**Proposed Temporary Private Vehicle Park (Private Cars) for a Period of 3 Years in
“Village Type Development” Zone, Lot Nos. 537 (Part), 538 (Part), 540 S.A (Part)
and 541 S.A (Part) in D.D. 218, Ma Kwu Lam Village, Sai Kung North, New Territories
(Application No. A/NE-SSH/155)**

Further Information for Planning Application Nos. A/NE-SSH/155&156**Response-to-Comment****Comments from Drainage Services Department received on 28.3.2024**

Further Information (4) for Planning Application Nos. A/NE-SSH/155**Response-to-Comment****Comments from Drainage Services Department received on 31.5.2024**

Plan 4.2a
(P 23055B)

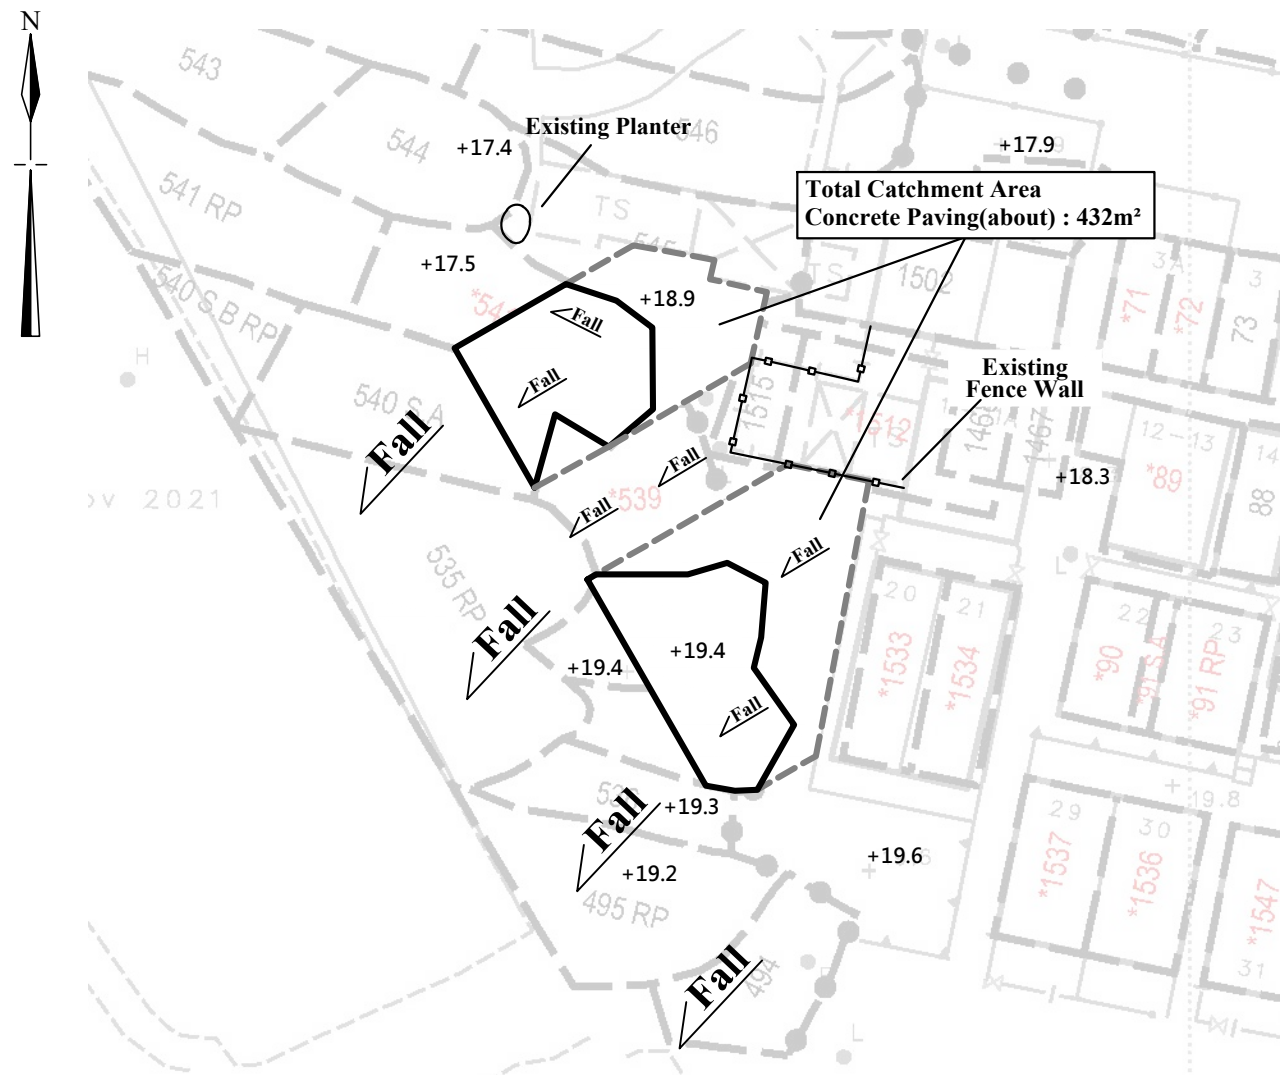
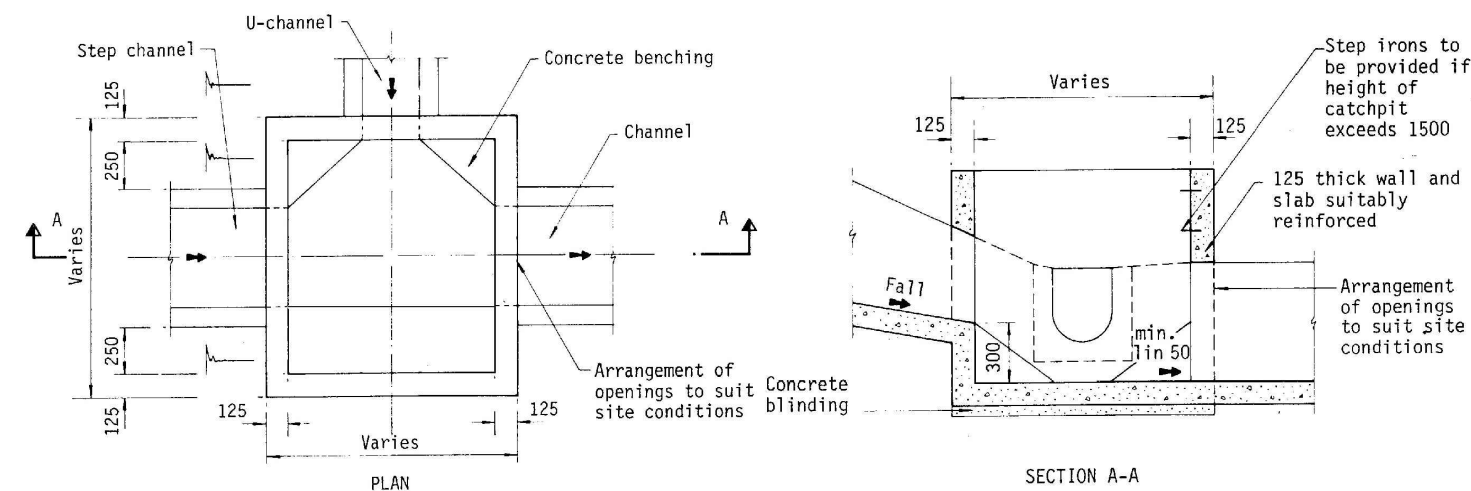
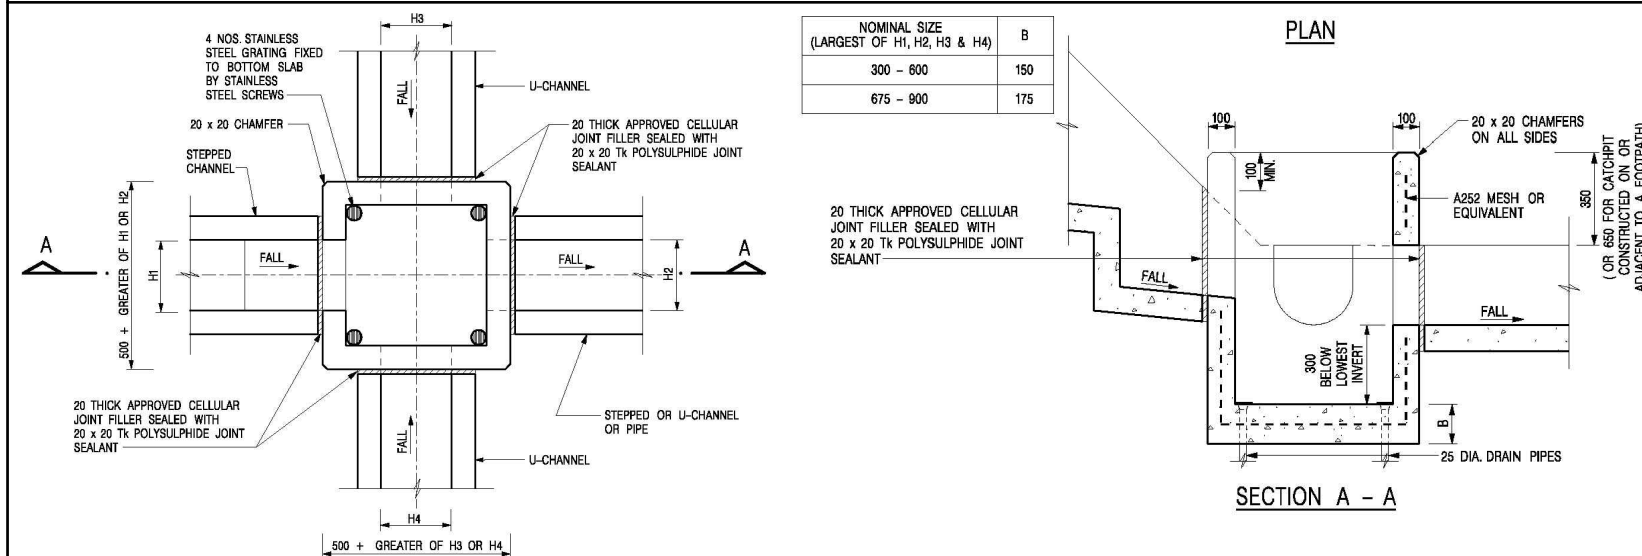
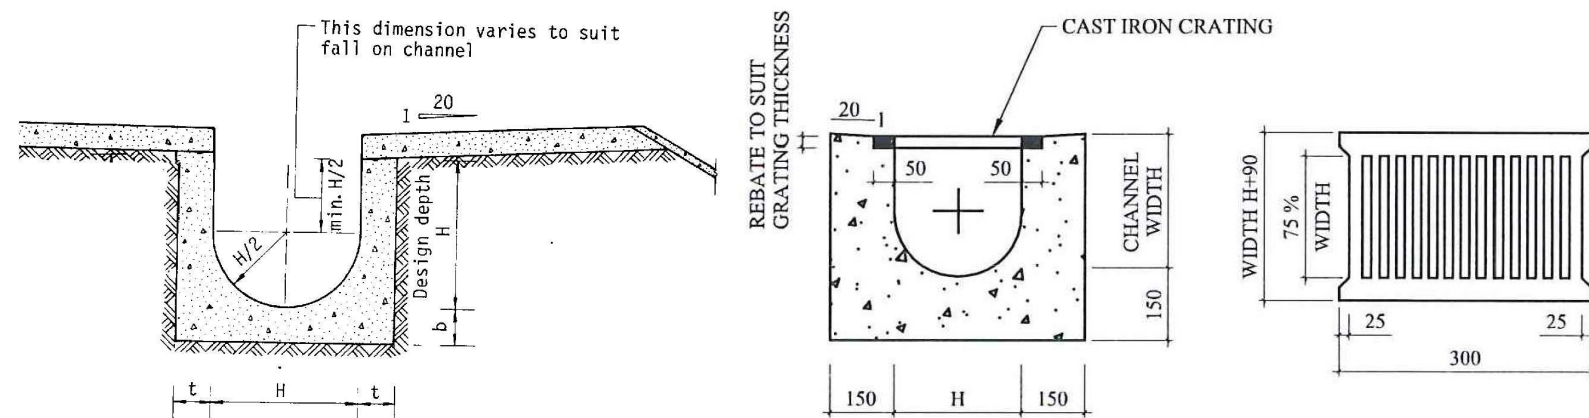
(b)	Please justify your proposed catchment area. (Please provide support evidence for all directions of the sites)	Ground levels of surrounding area are indicated on Plan 4.2a to justify the proposed catchment area.

Viewpoint 1

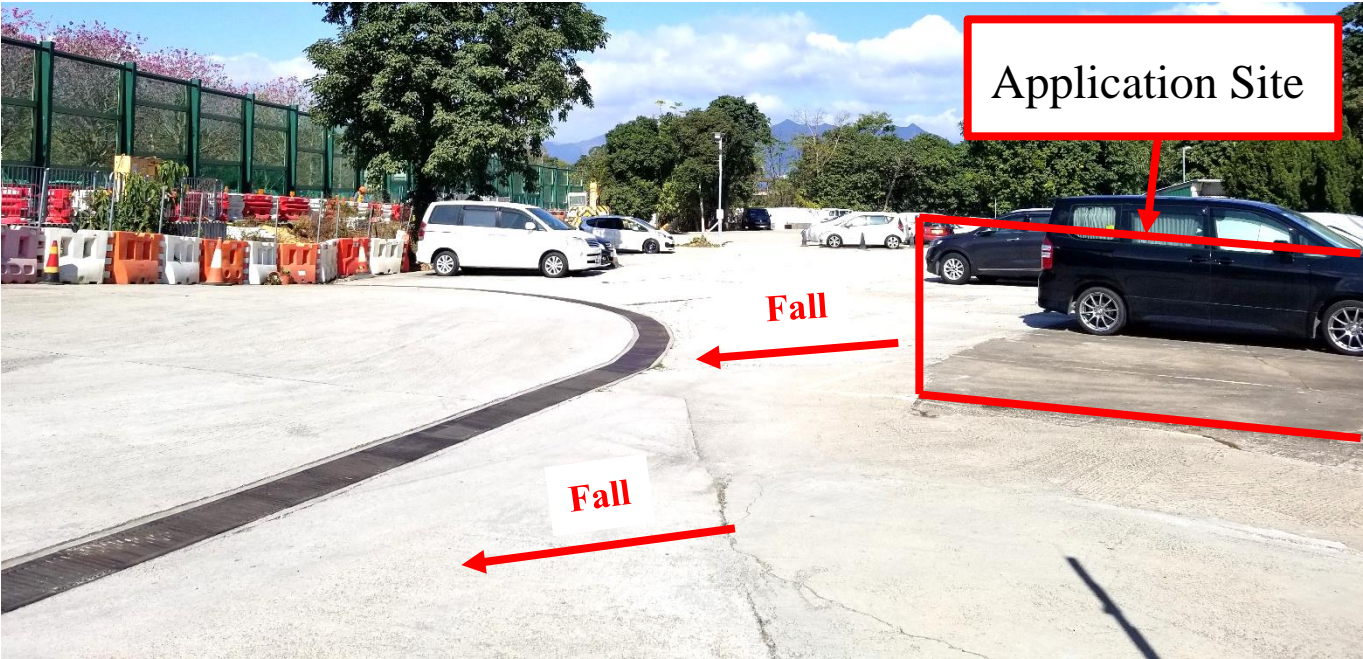
(c)	The drainage flow path from the development to the public drainage system / streamcourse / sea / any recognized drainage facilities should be provided in association with supporting site photos for the captioned submission. (Please provide downstream information of existing 250UC for SSH_155).	Please refer to the attached site photo showing the drainage flow path to local village drainage facilities.

1:300 (A3)	Drainage Proposal Lots 537(part), 538(part), 540 S.A(part) and 541 S.A(part) in D.D.218 Ma Kwu Lam, Sai Kung North, N.T	Goldrich Planners & Surveyors Ltd.
July 2024		Plan 4.1b (P 23055B)

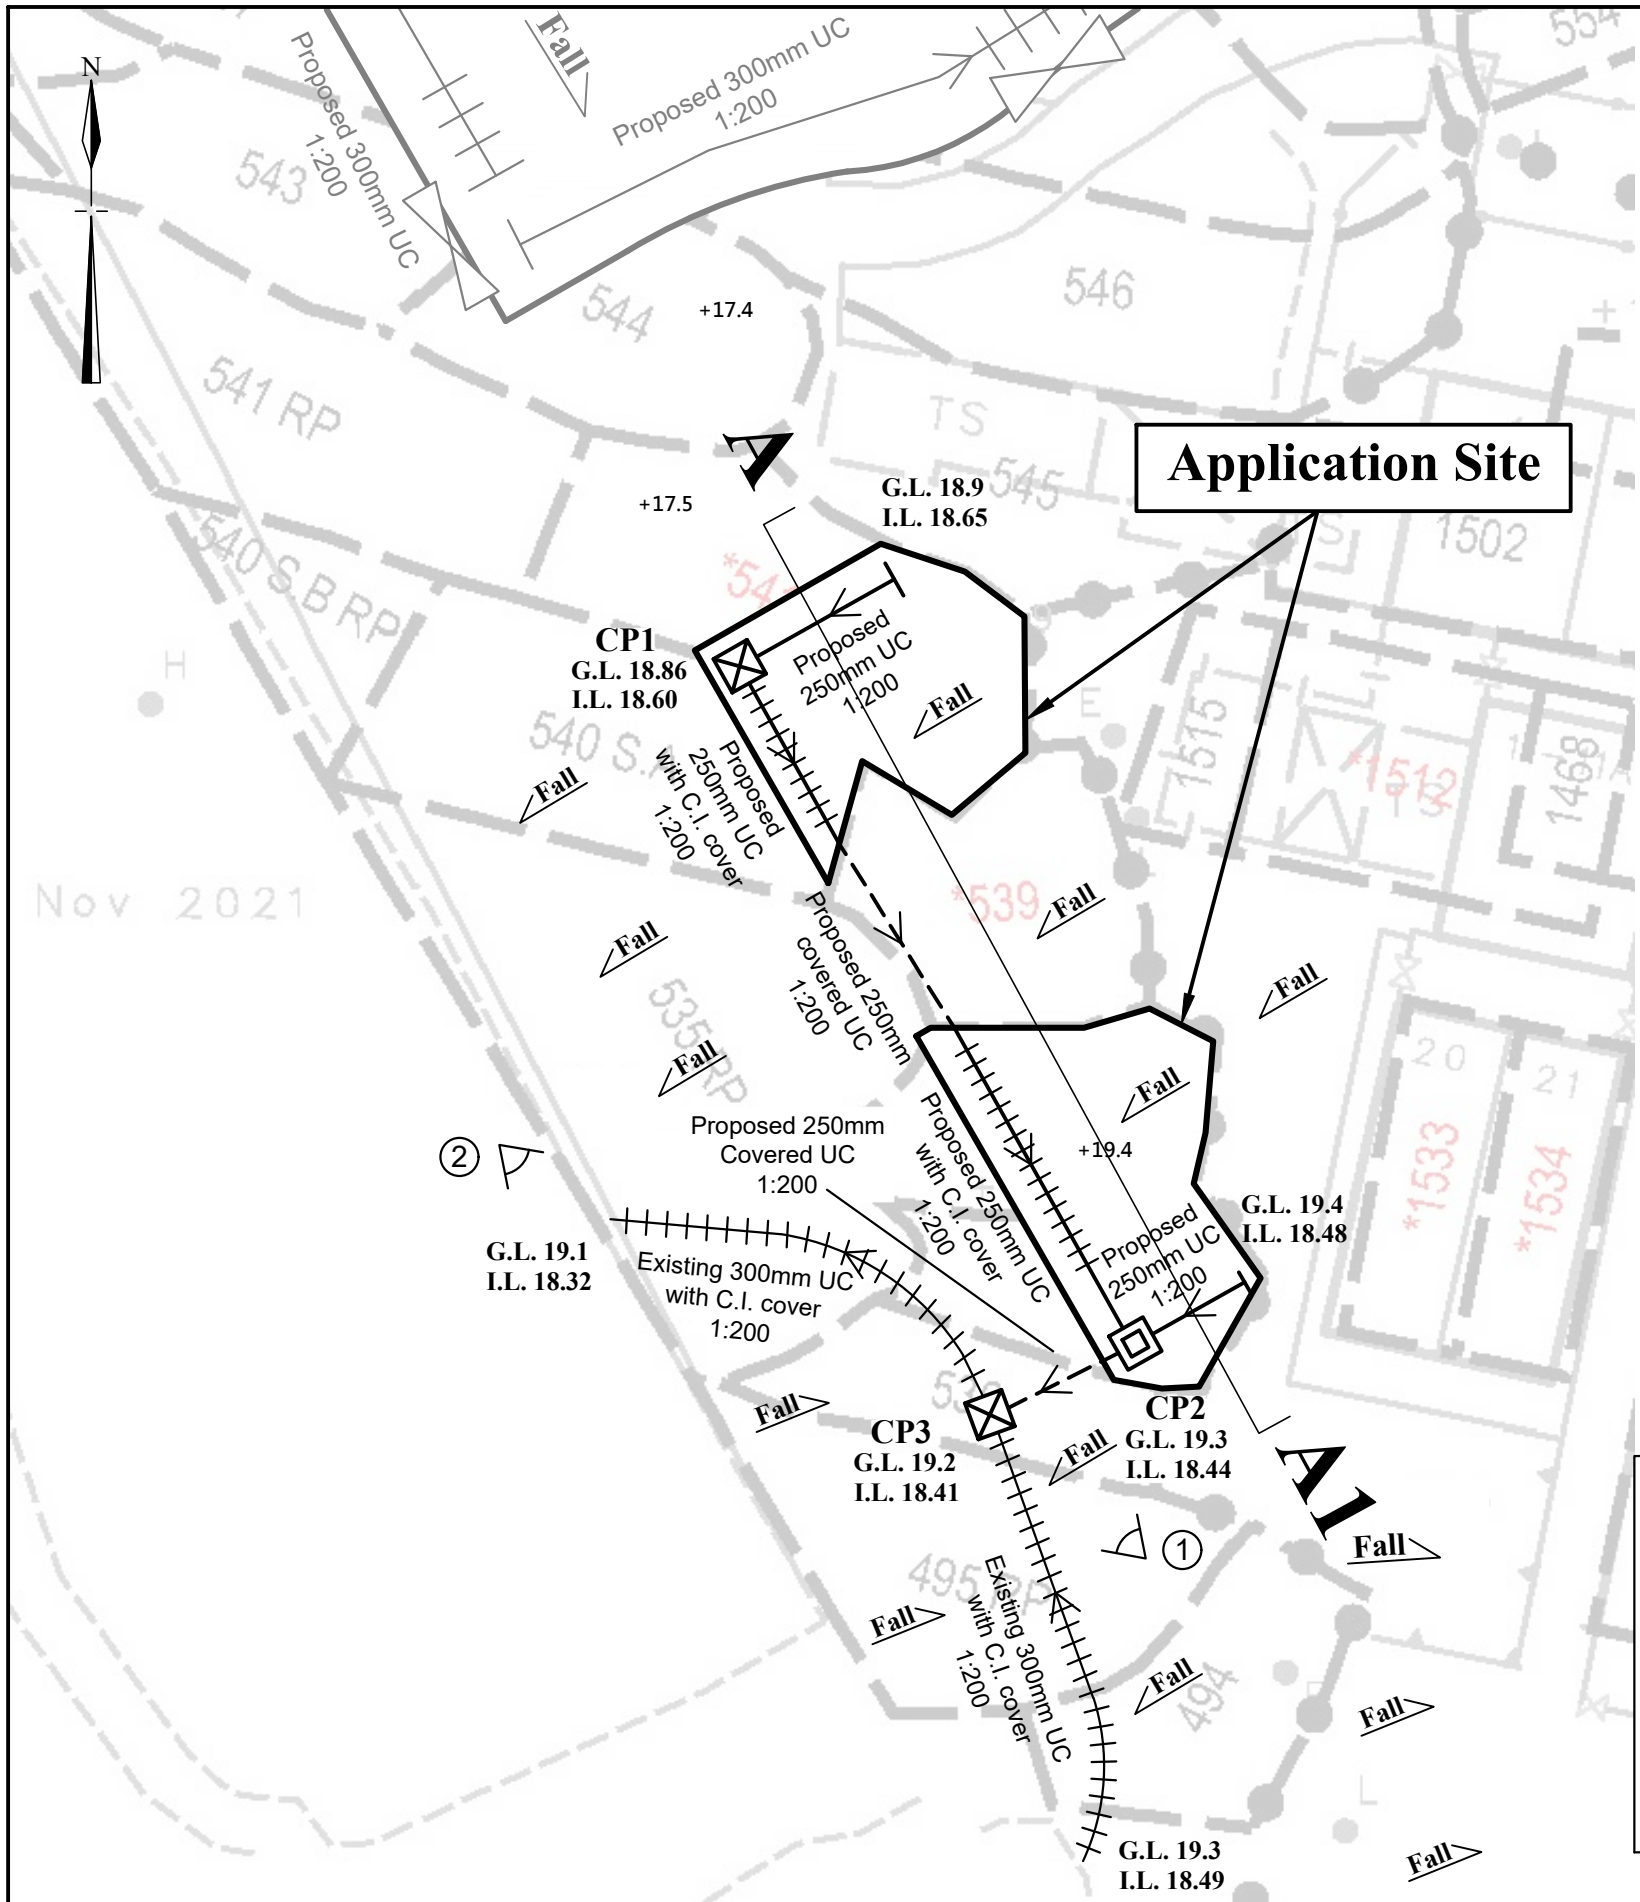
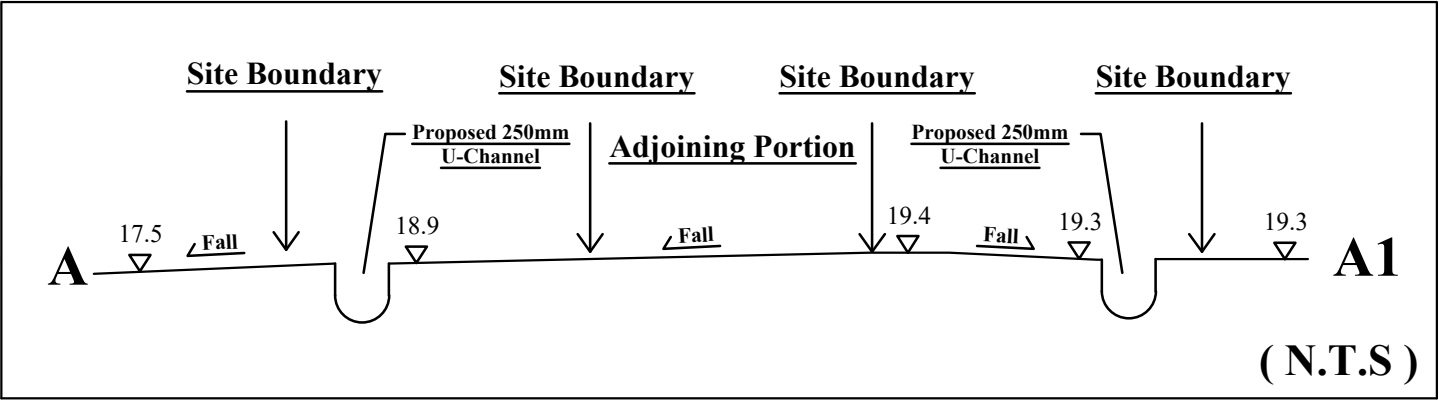
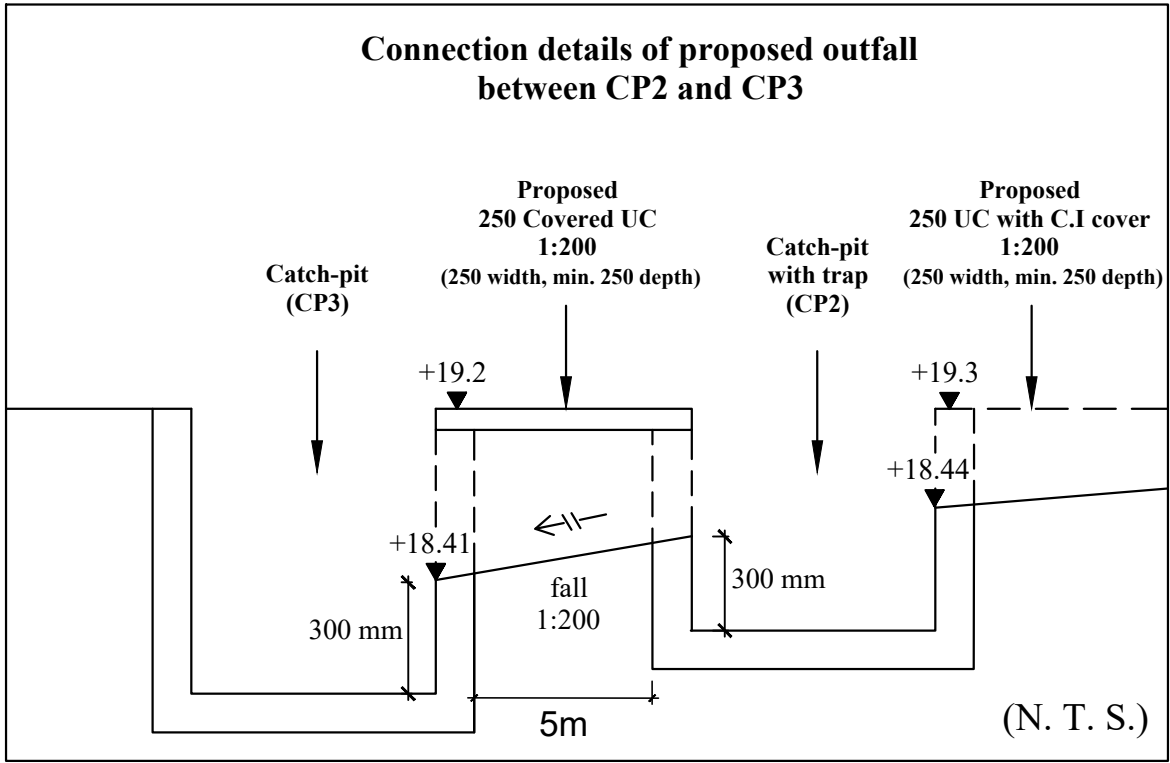
I.	Comment	Response
(a)	Supporting calculations to demonstrate that the existing downstream drain/channel has adequate capacity to convey the runoff to be discharged arising from the proposed development. (Checking for existing 300UC and its downstream for SSH_155)	Please refer to updated Drainage Proposal (Plan 4.1b and Plan 4.2b) and drainage calculations for details.
(b)	The drainage flow path from the development to the public drainage system / streamcourse / sea / any recognized drainage facilities should be provided in association with supporting site photos for the captioned submission. (Please provide downstream information of existing 300UC for SSH_155)	Please refer to attached site photo (Viewpoint 2) for details.
